Date Created : 2007/12/25  
Date Issued On : 2008/01/03  
PCN# : Q4075201

INFORMATION ONLY NOTIFICATION

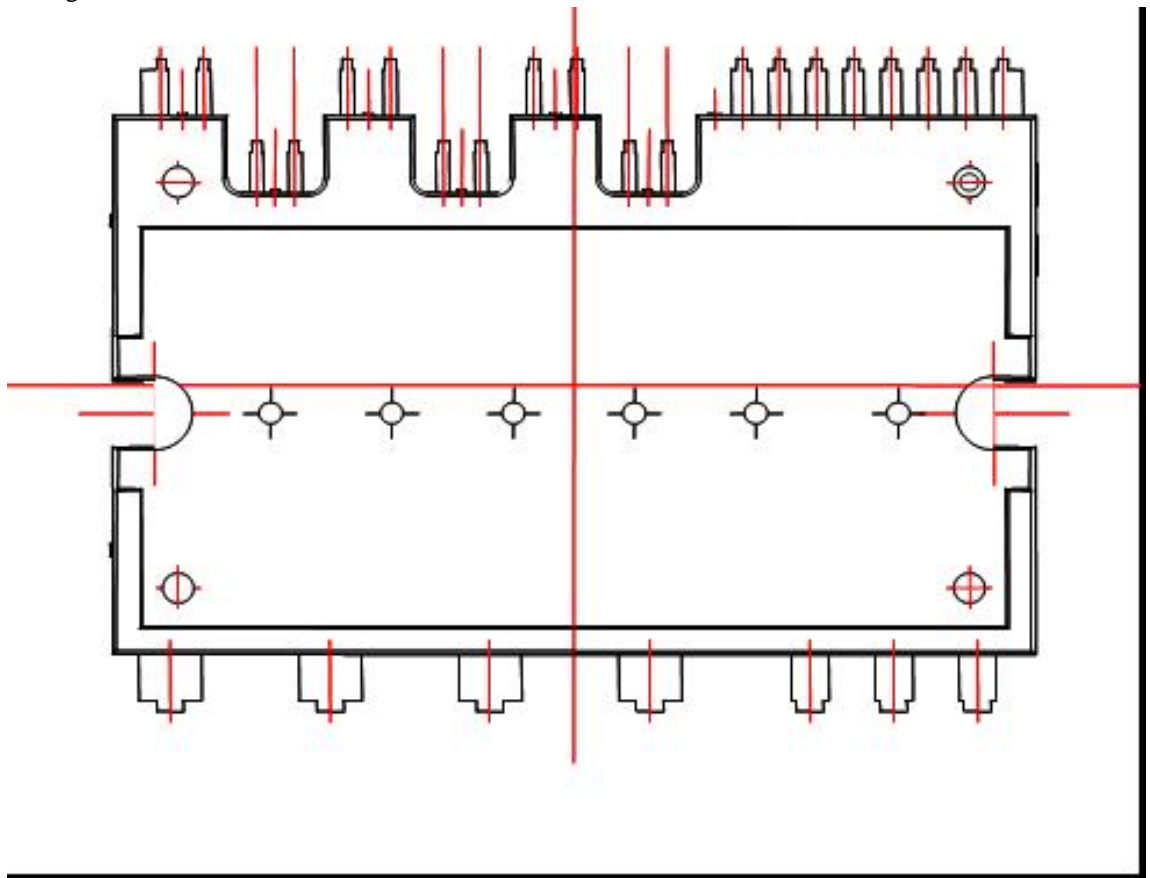
Description of Change (From): Bottom Retract pin position in signal pin side

Description of Change (To): Bottom Retract pin position in signal pin side in Center area

Reason for Change : Quality improved by increasing mold ability
